Change Order

PROJECT: (Name and address) Williamson County Animal Shelter Expansion 1855 SE Inner Loop Georgetown, TX 78626

Change Order Number: 007

Change Order No. 7 includes the below listed Vaughn Change Proposals # 32-#39 and #41-42. For Vaughn Project No. 2491-01.

ELECTRICAL PANELBOARD SCHEDULES

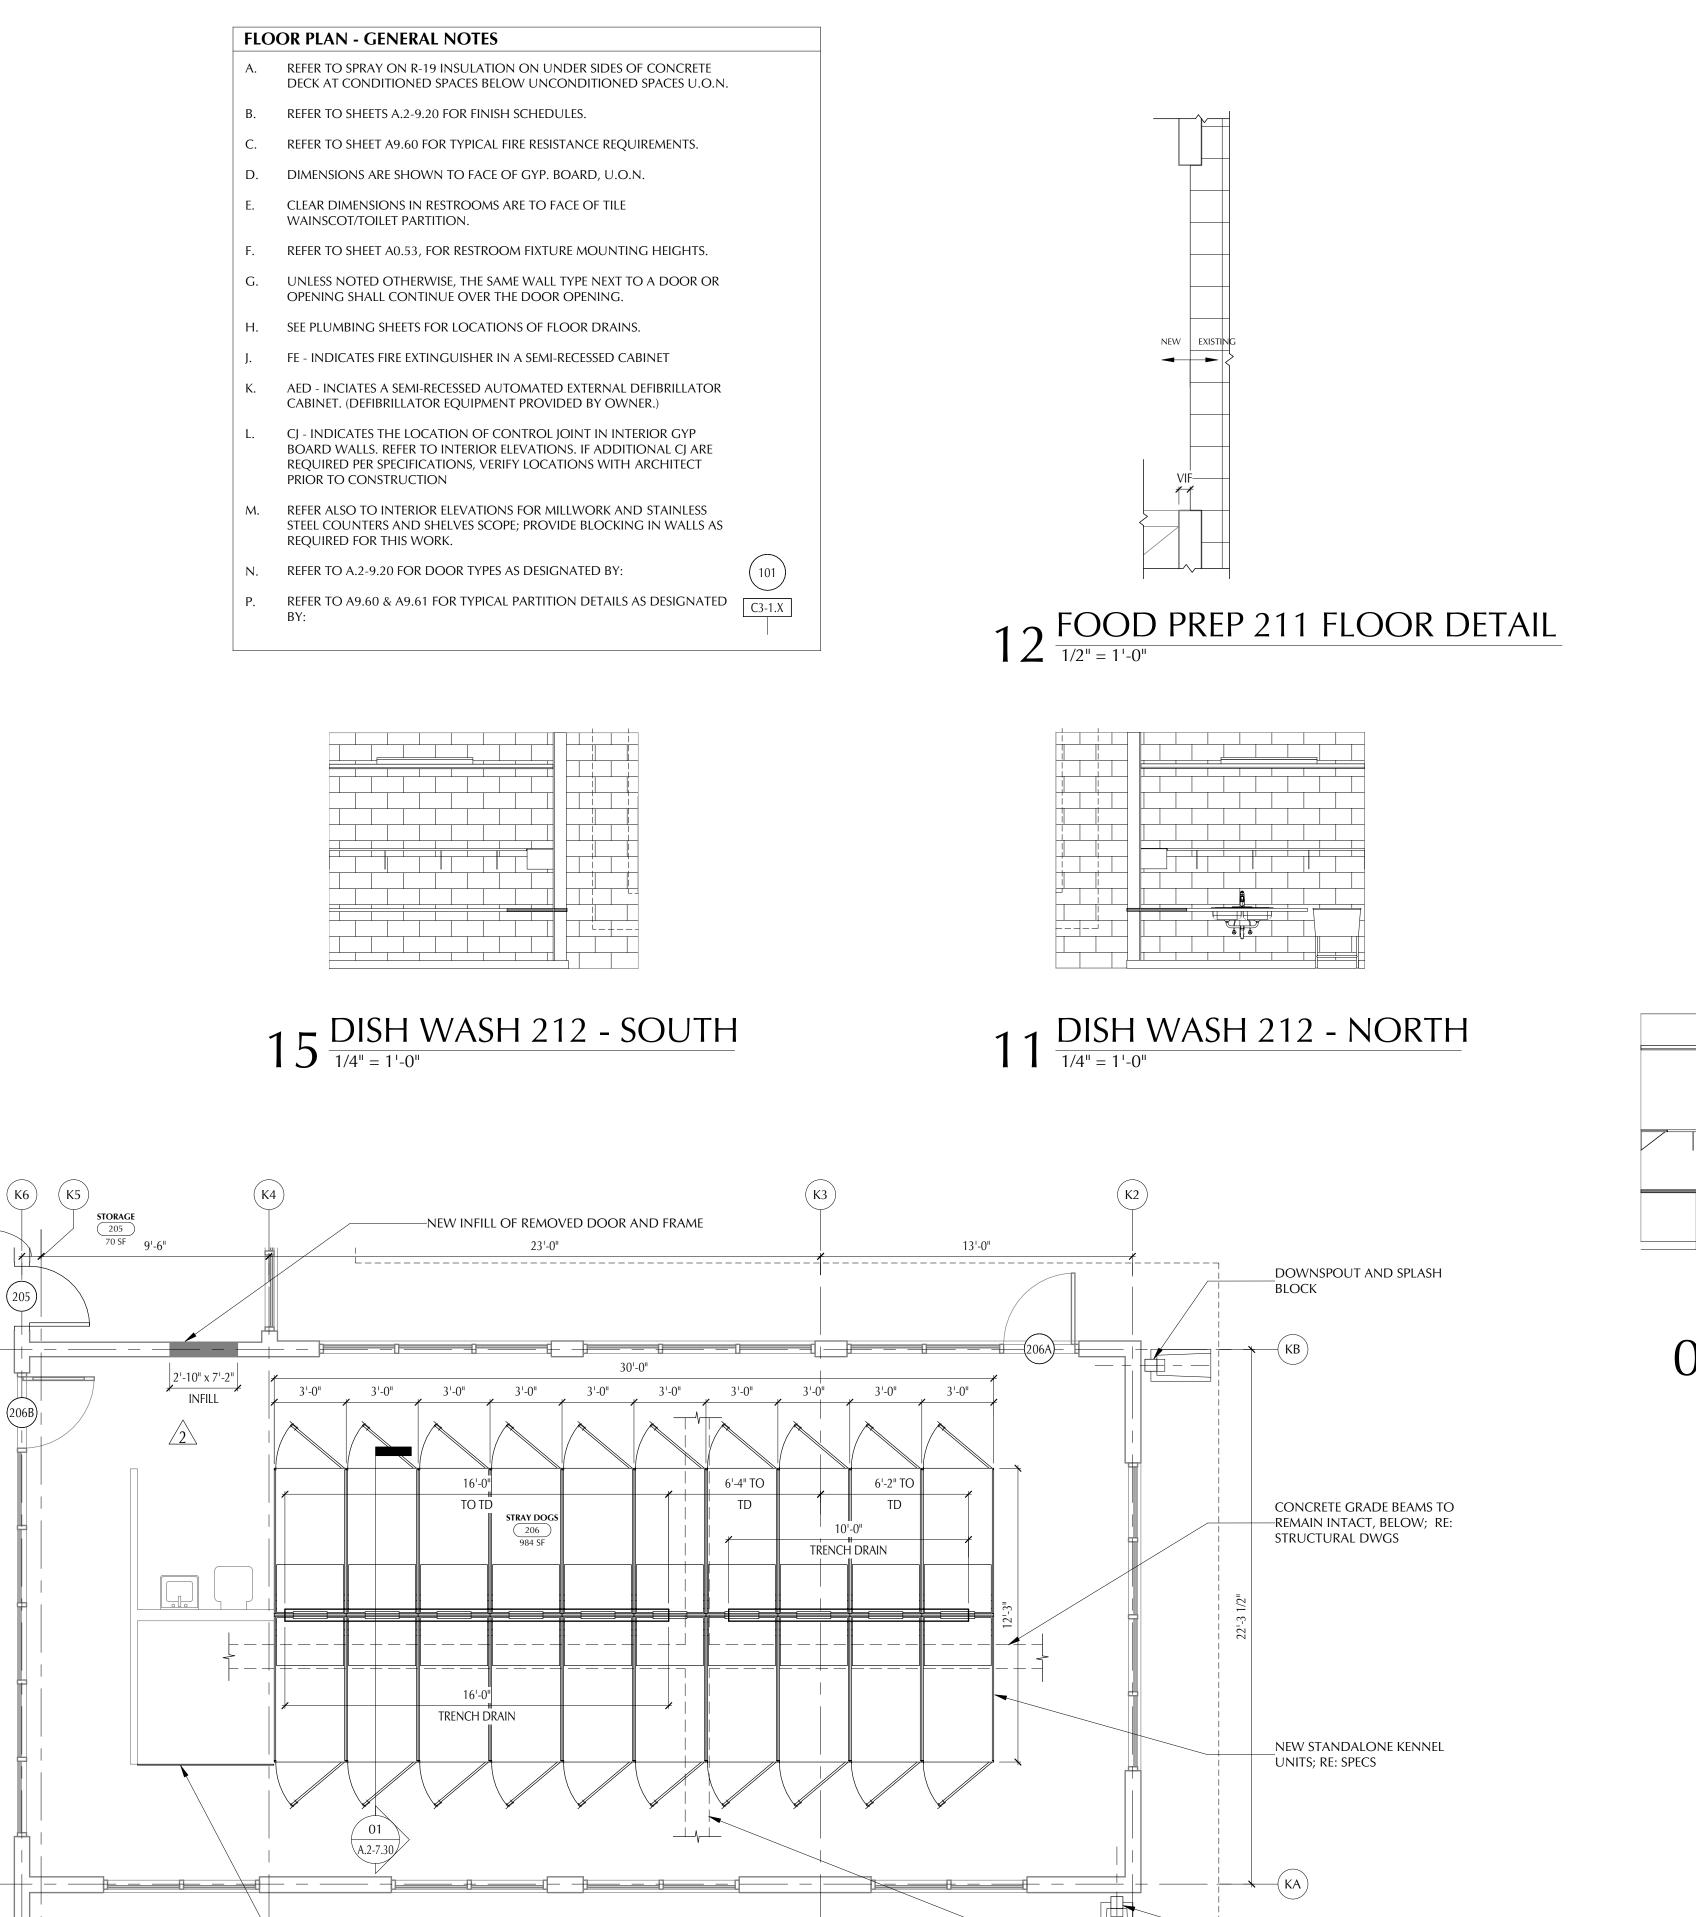
ASI 007 submits information for the Plumbing and Electrical connections for the additional Spray Master Technologies wash-down pumps serving the existing Kennel Building.

KENNEL - RENOVATION -POWER PLAN - LEVEL 1

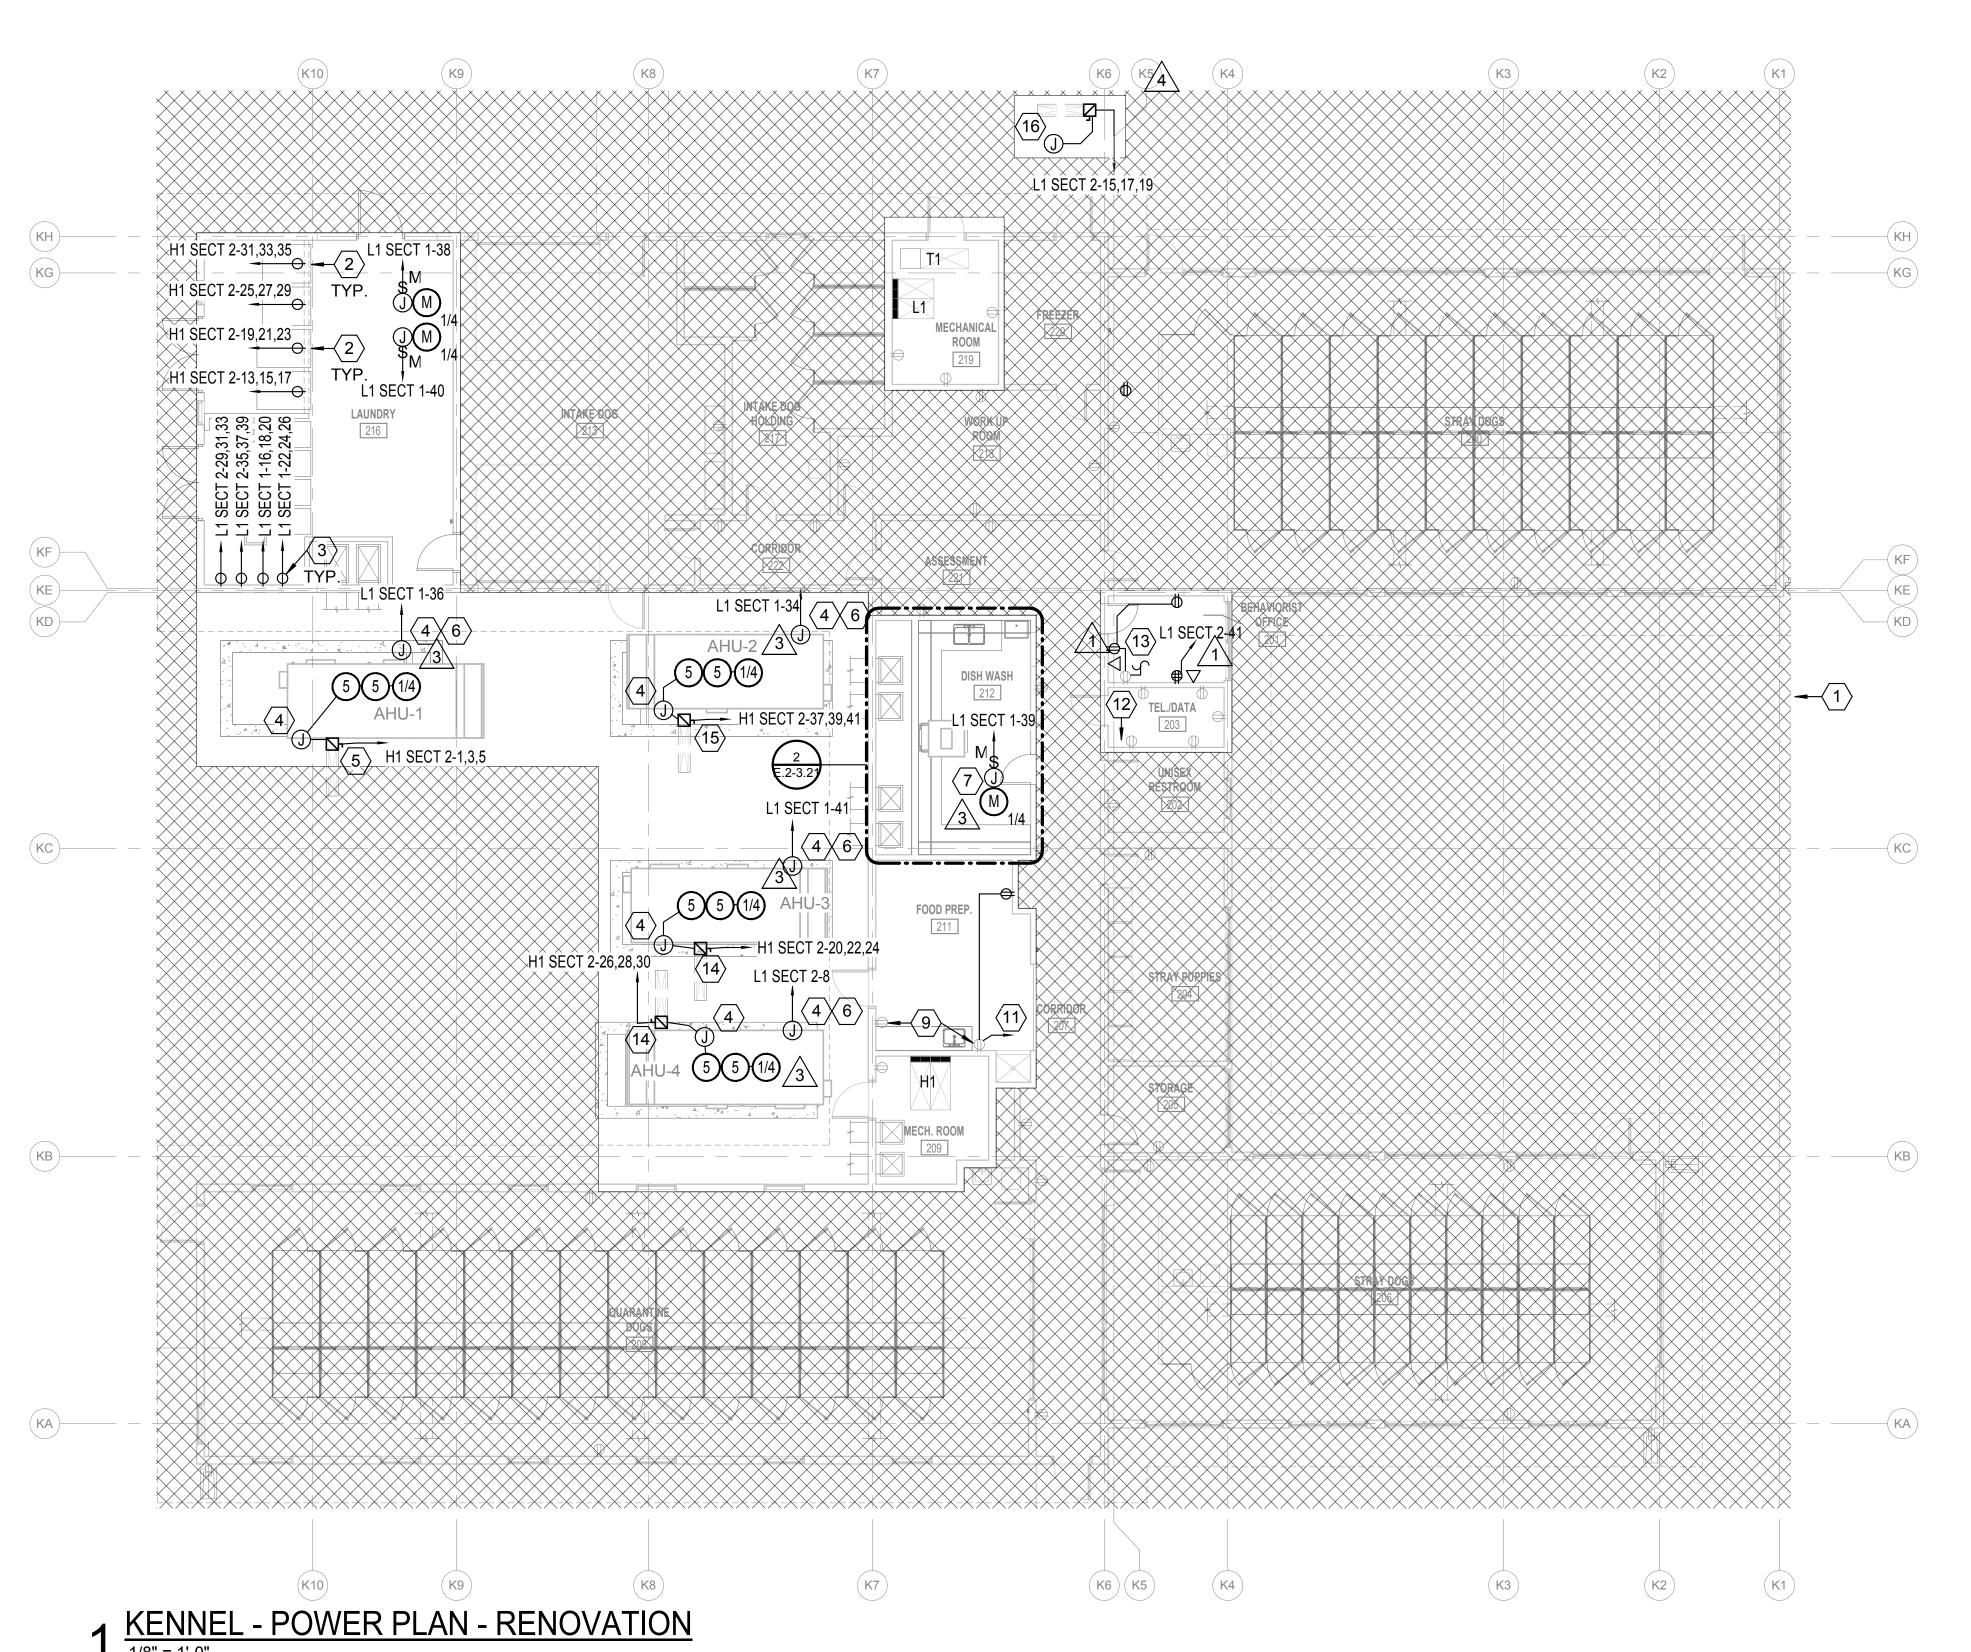
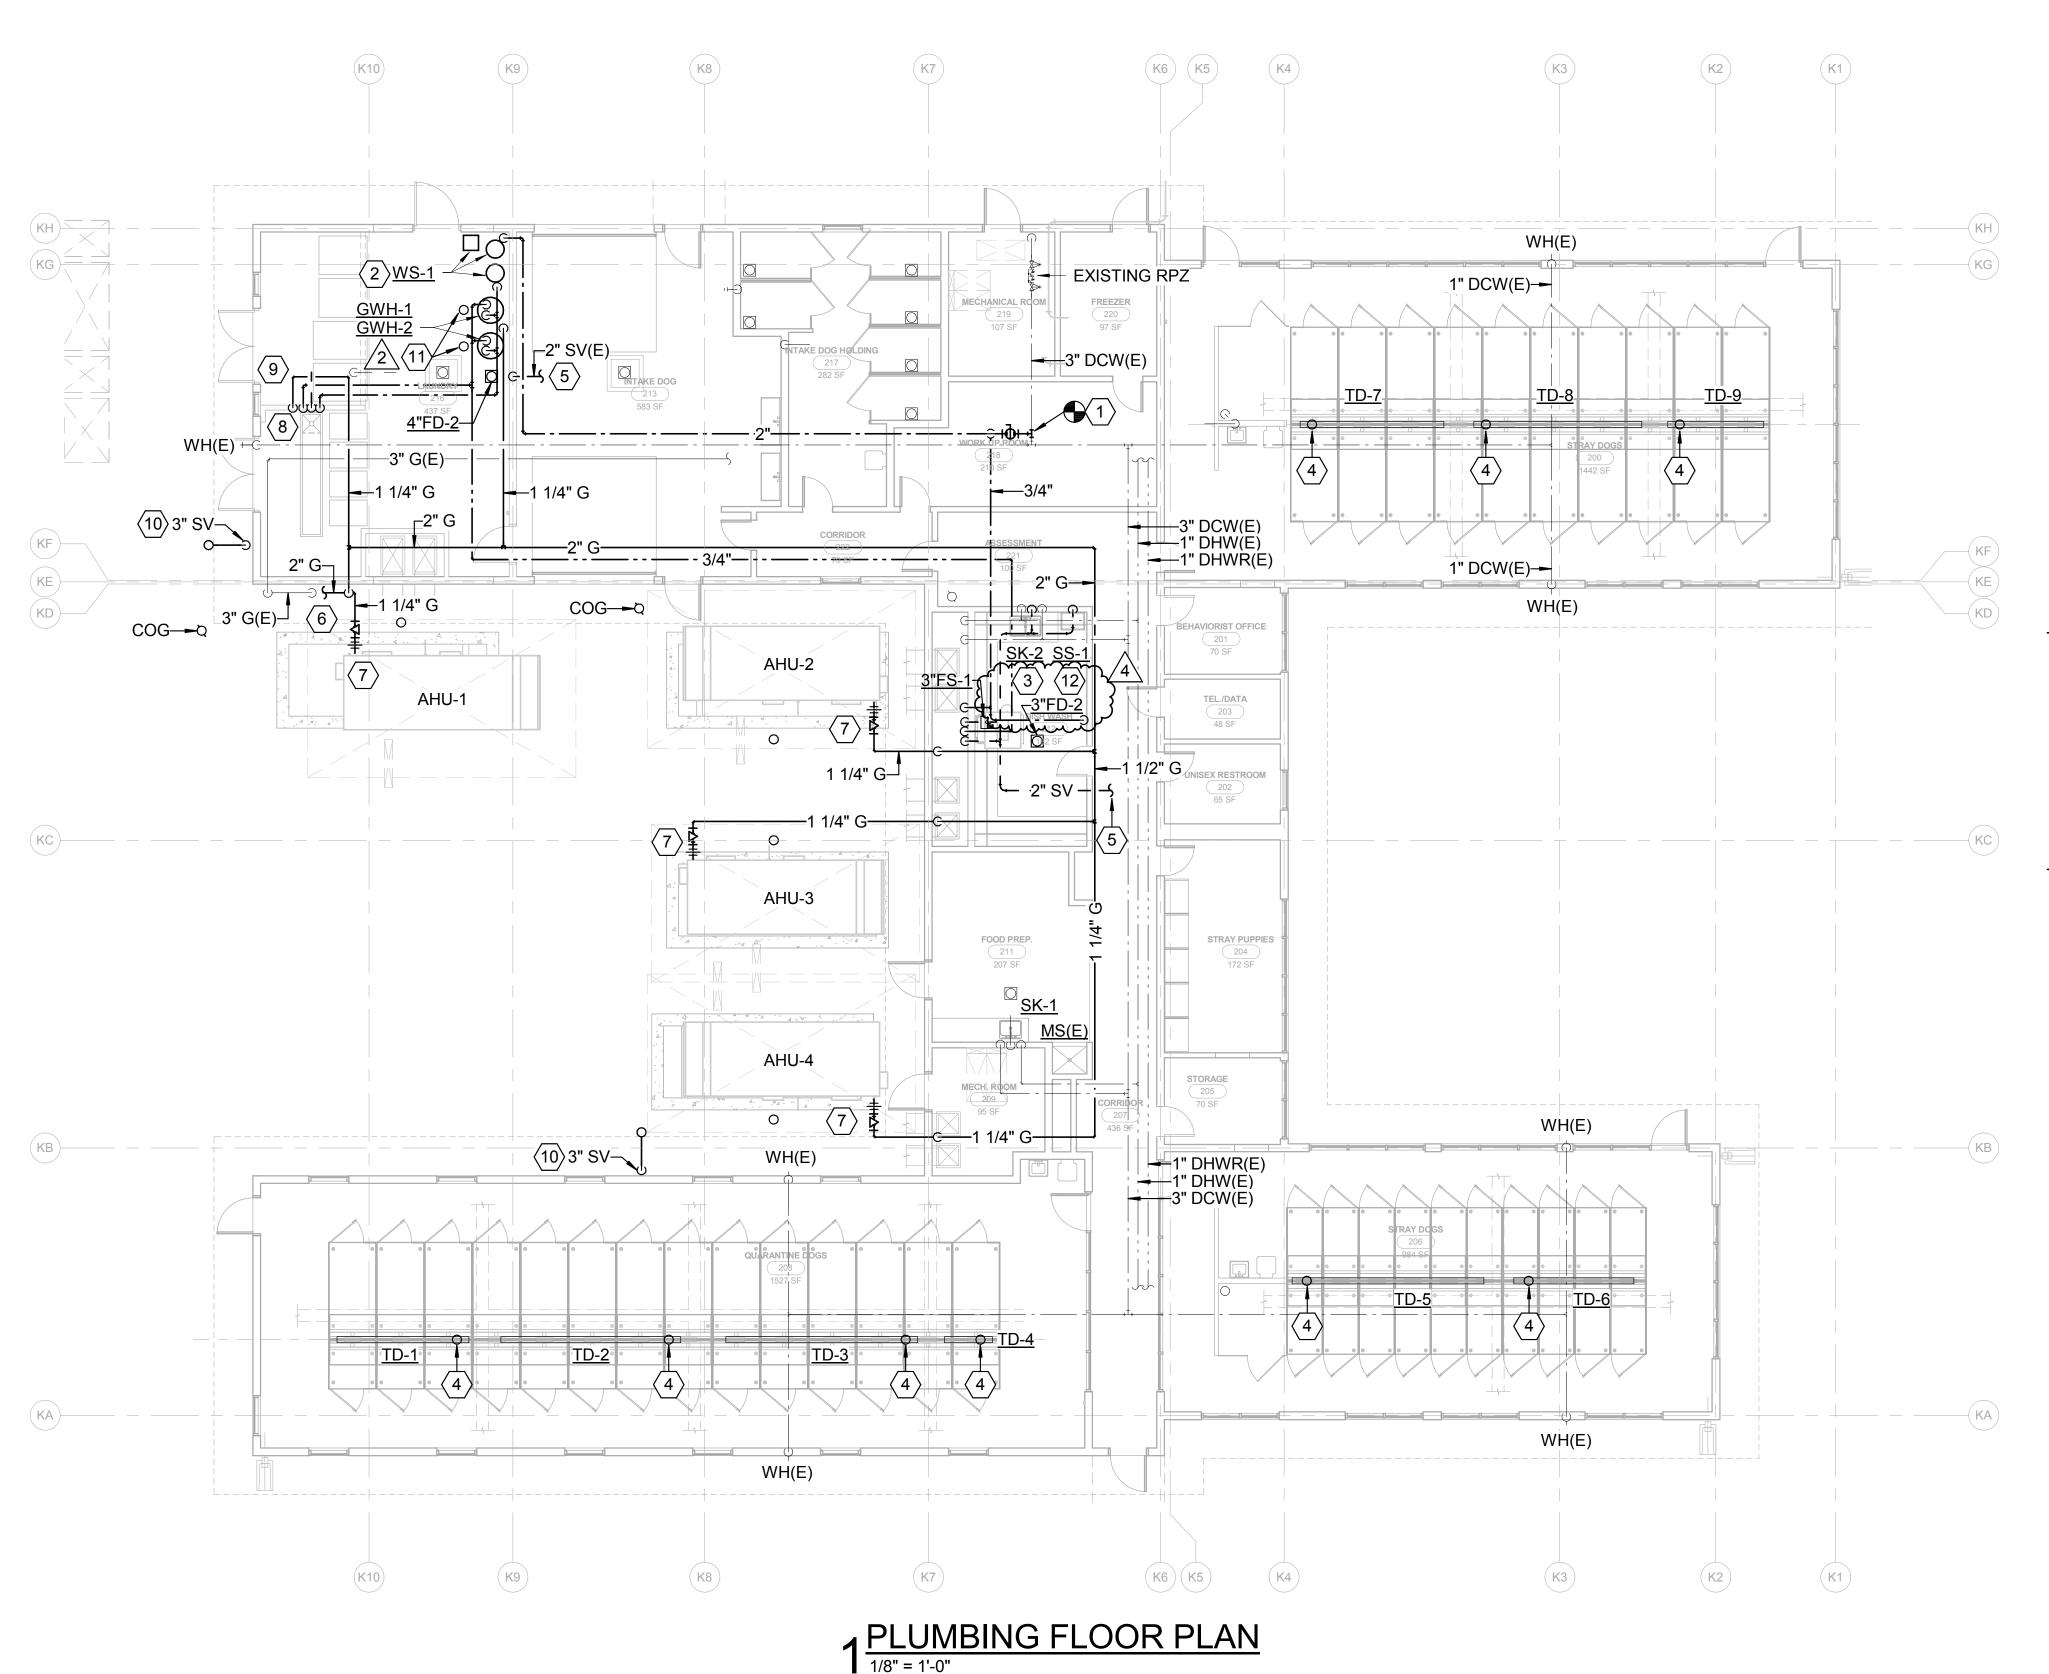
REFRIGERANT LINE. INSTALL RELOCATED **DISCONNECT. REUSE EXISTING CIRCUIT** BREAKER IN PANEL L1 SECT 2. PROVIDE POWER TO STACKED WASH-DOWN **PUMPS. PROVIDE NEMA 5-20R AND NEMA** L6-30R PER PUMP. COORDINATE ELEVATIONS WITH PUMP SUPPLIER.
